**DOCUMENT 00 90 00
ADDENDUM**

ADDENDUM NO. [1] Date: February 17, 2020

**RE: WESTERN TECHNICAL COLLEGE
 APPRENTICESHIP CENTER REMODEL
 2860 21ST PLACE SOUTH
 LA CROSSE, WISCONSIN 54601
 HSR PROJECT NO. 19021**

This Addendum consists of [2] page, [1] specification sections and [9] 30 x 42 drawings.

1 FIRST FLOOR REMODEL PLAN
1/8" = 1'-0"

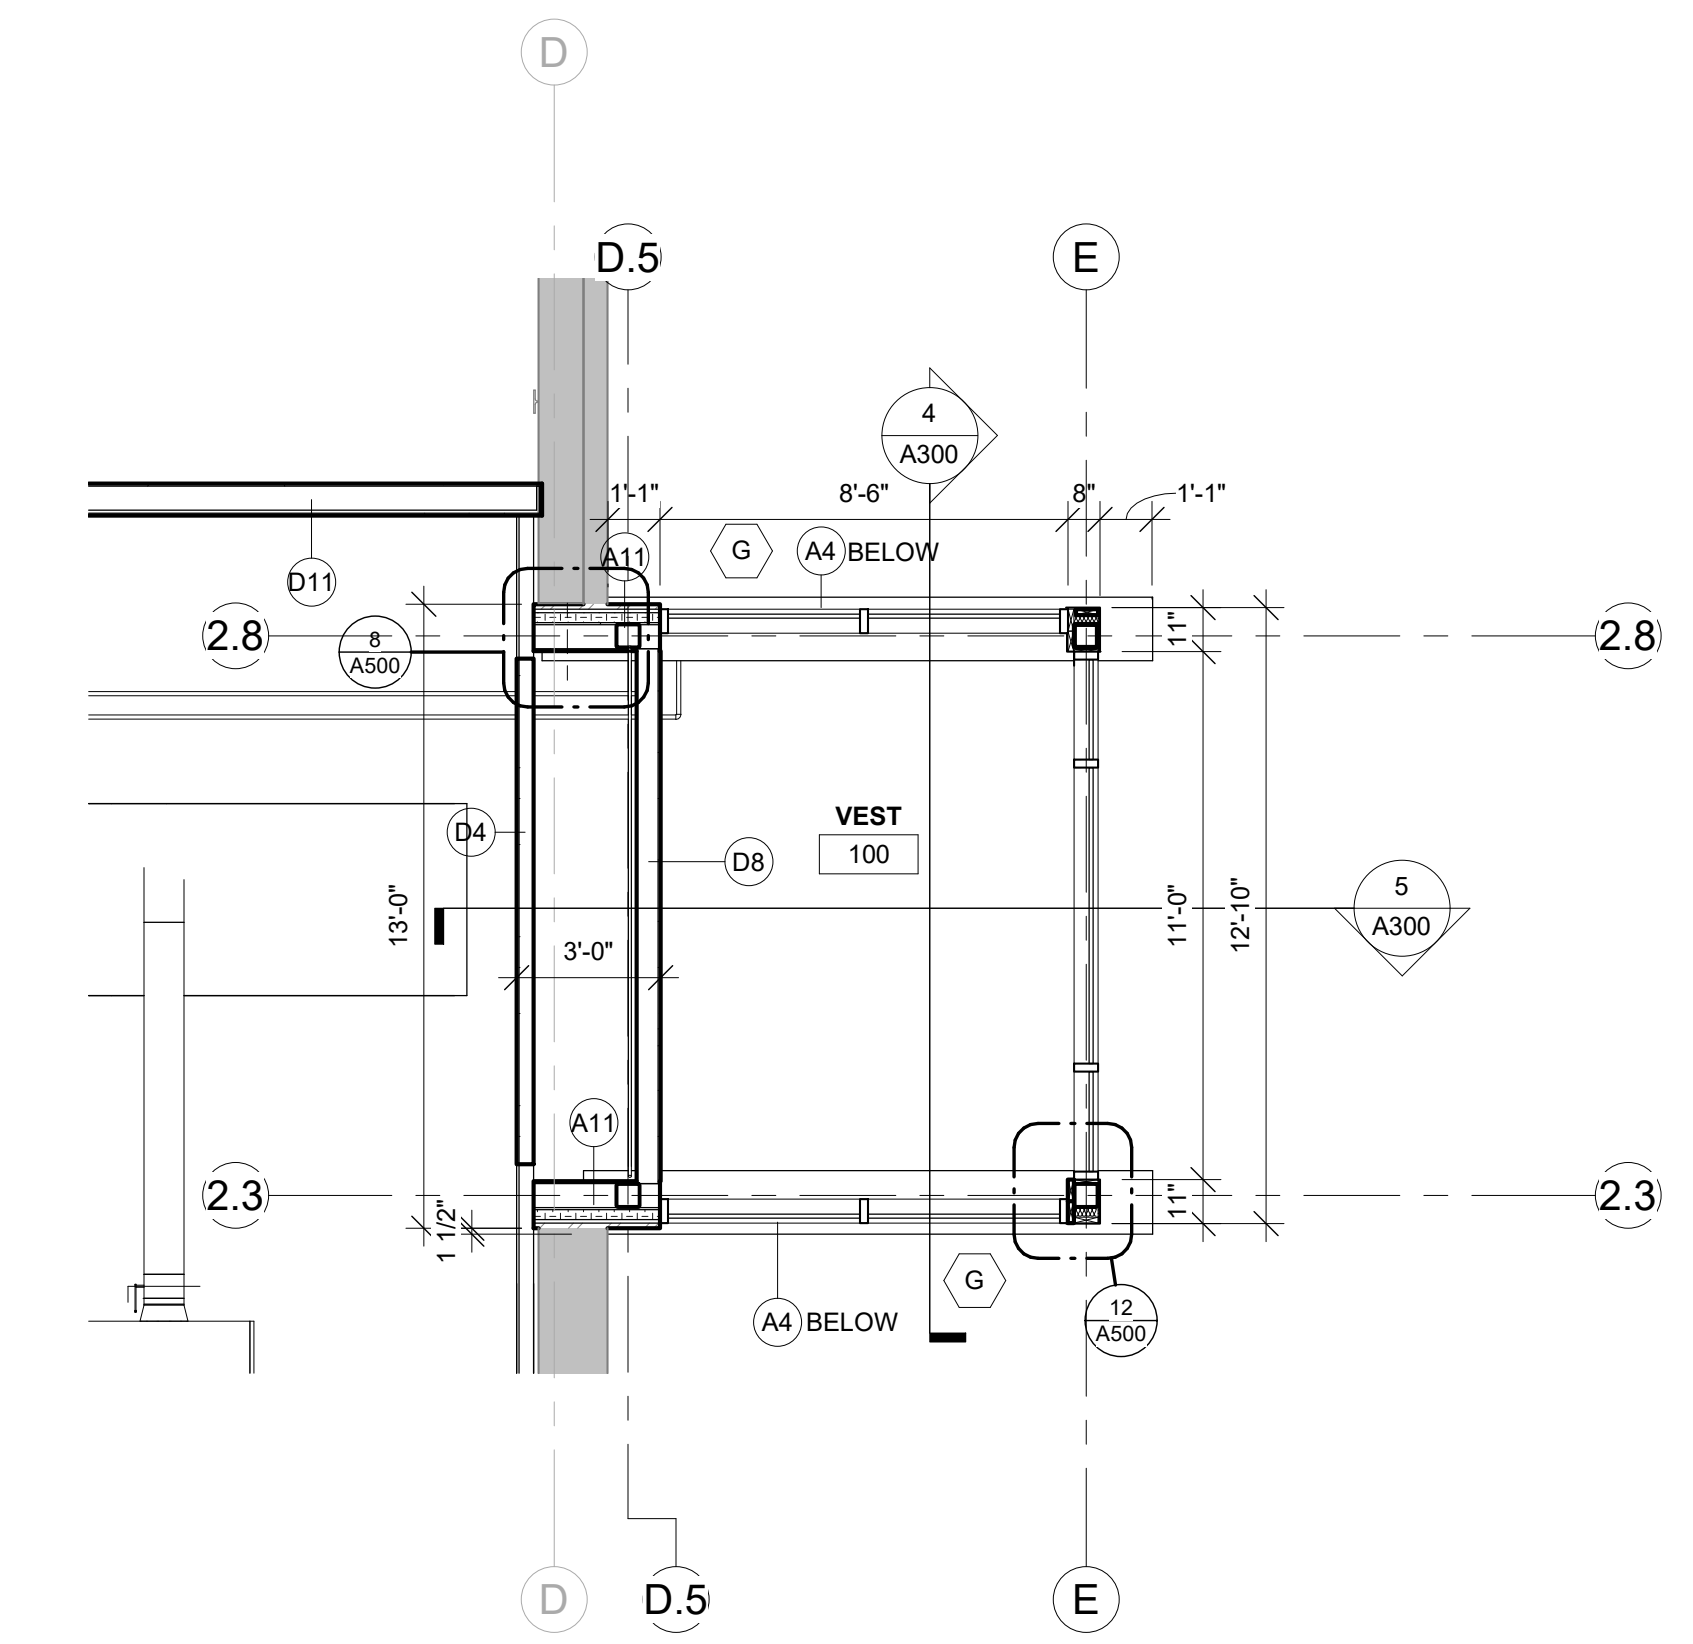
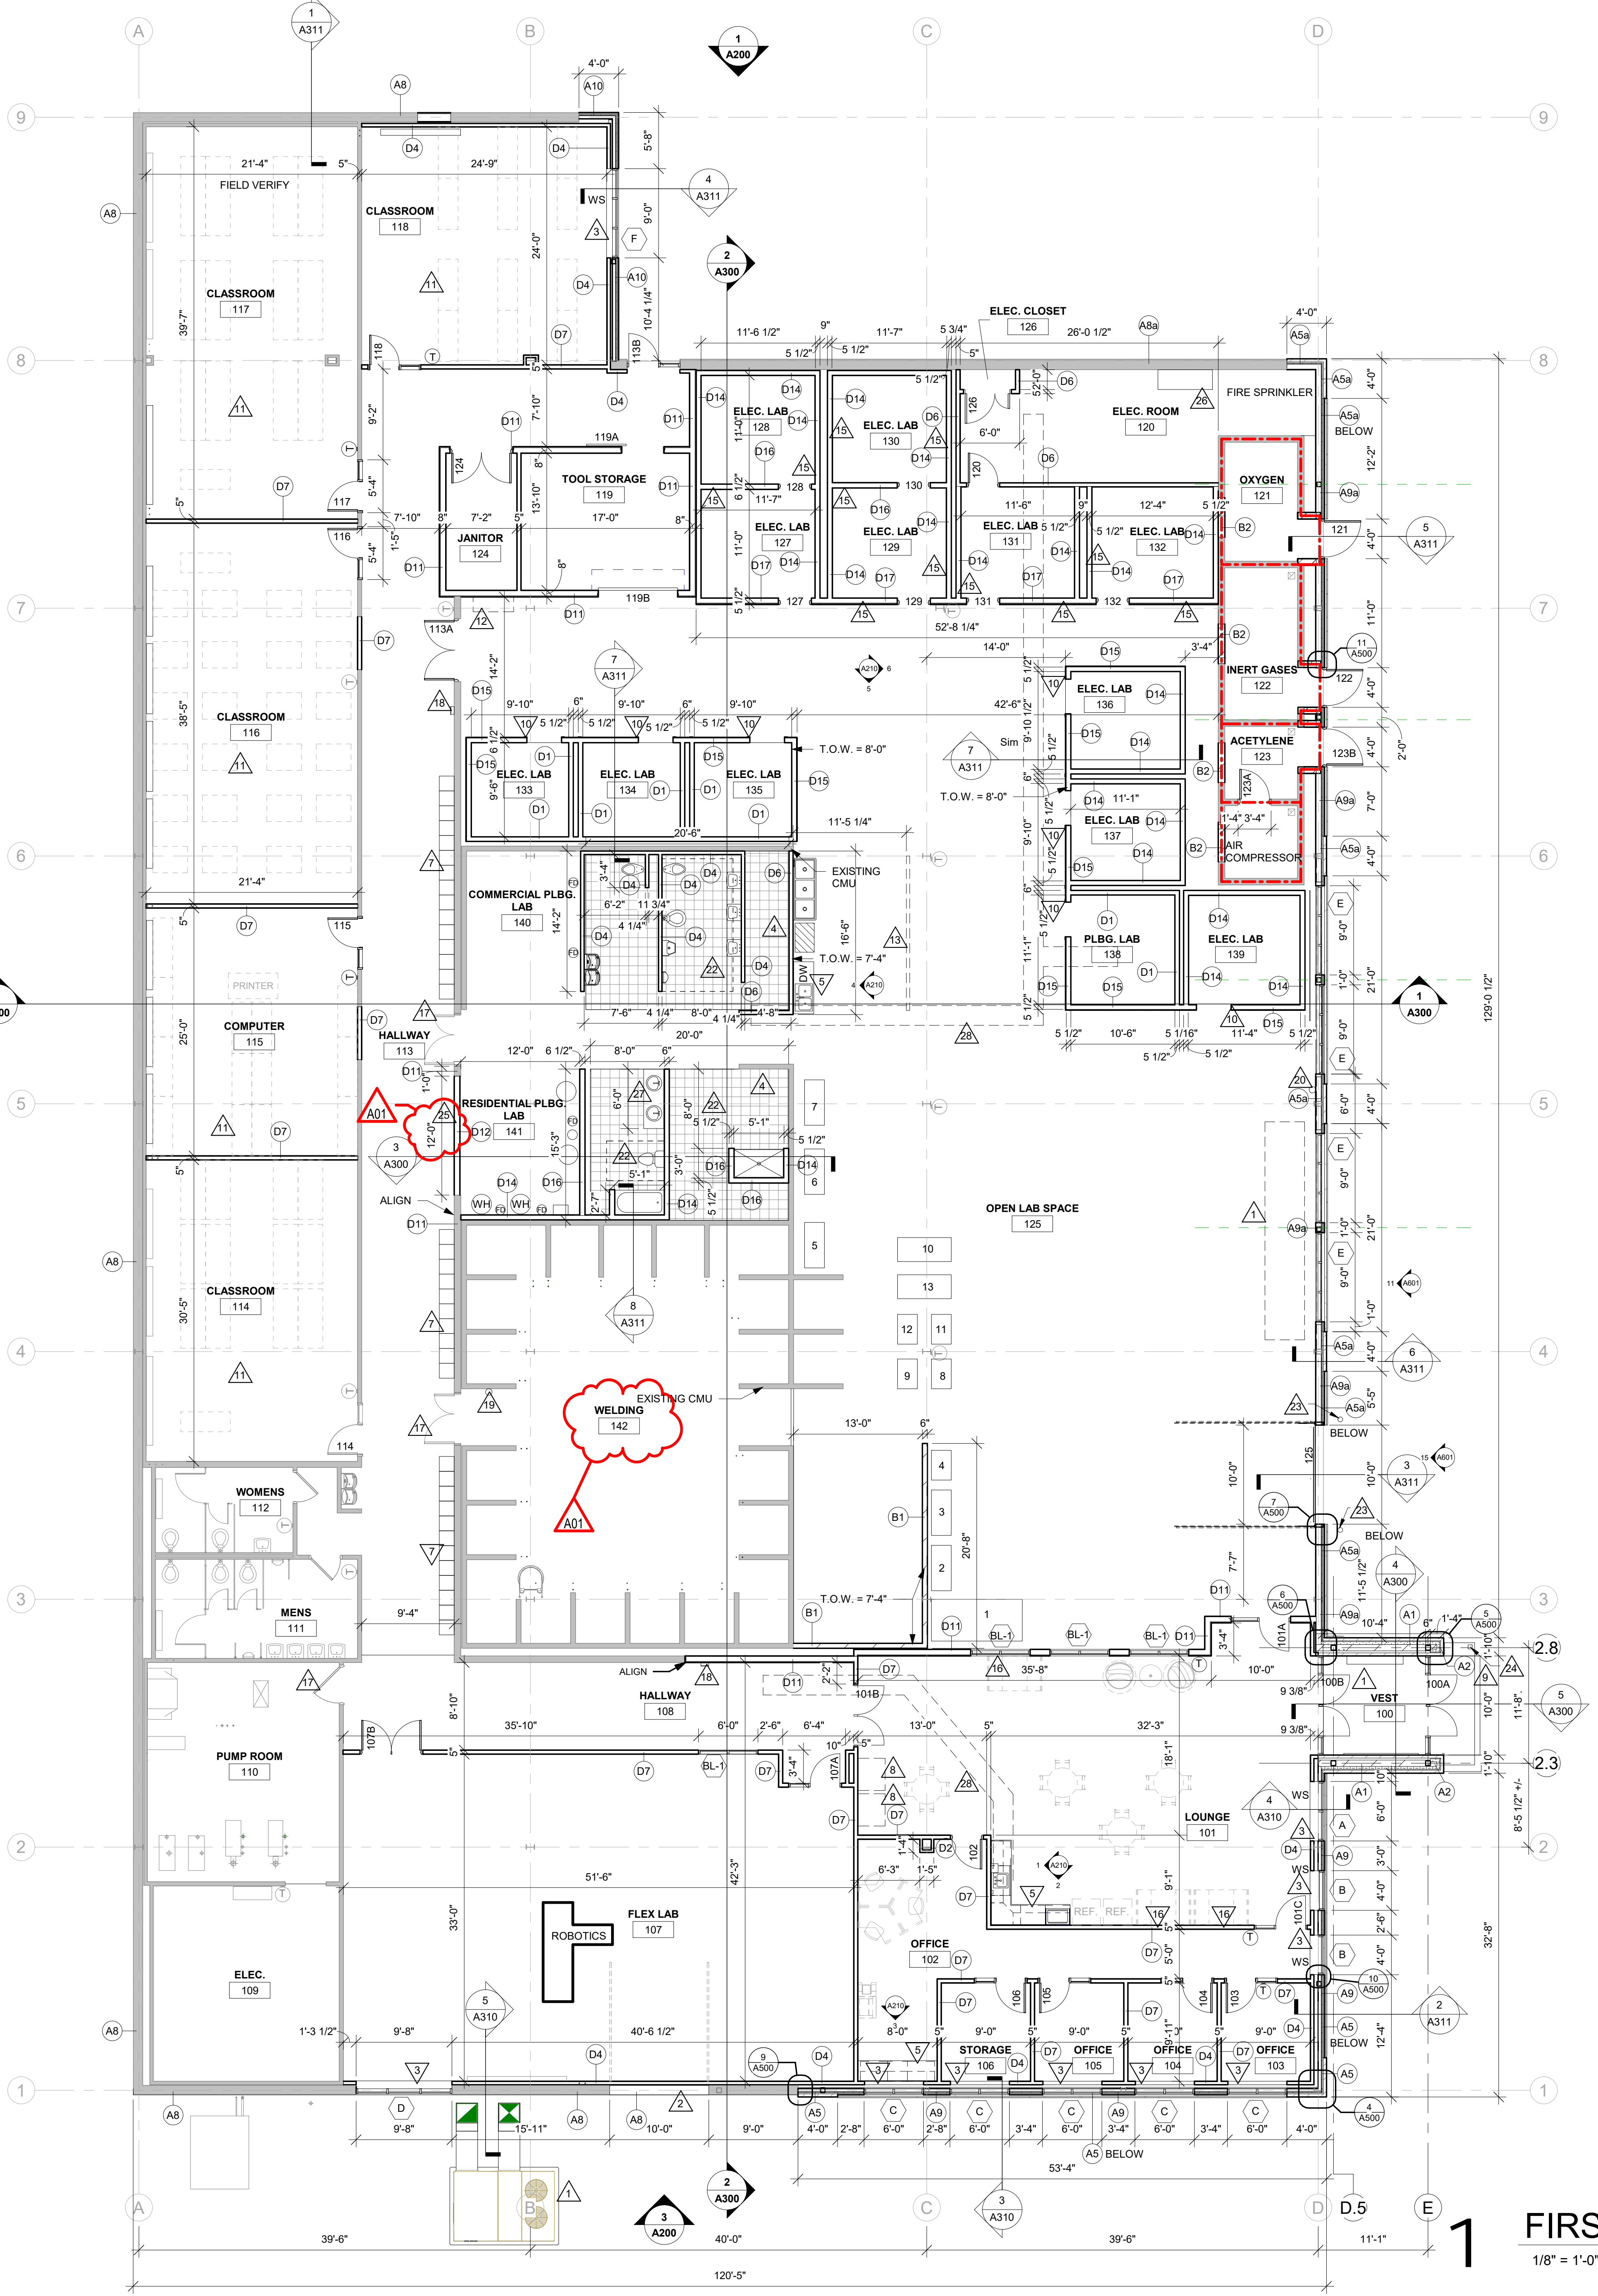
4. Sheet C200 LAYOUT PLAN 30 x 42 attached hereto
 - a. Revisions clouded on Drawing.
5. Sheet A100 FIRST FLOOR REMODEL PLAN 30 x 42 attached hereto
 - a. Revisions clouded on Drawing.
